**TEST CODE SHEET CLARIFICATION**

Issue No. 1  
Date of Issue: January 2016

NOTE: This clarification applies to **TCS 2212.6 : Issue 4**

Figure 75

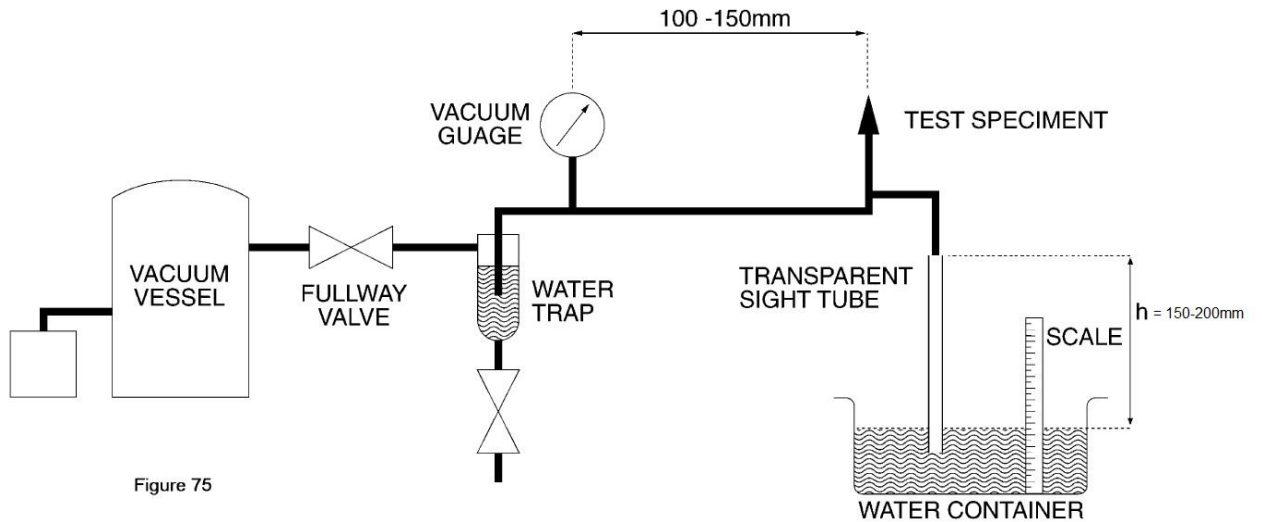
**Correction to dimension h, schematic should state 150-200mm in accordance with the test procedure.**

Dimension h =150mm – 200mm
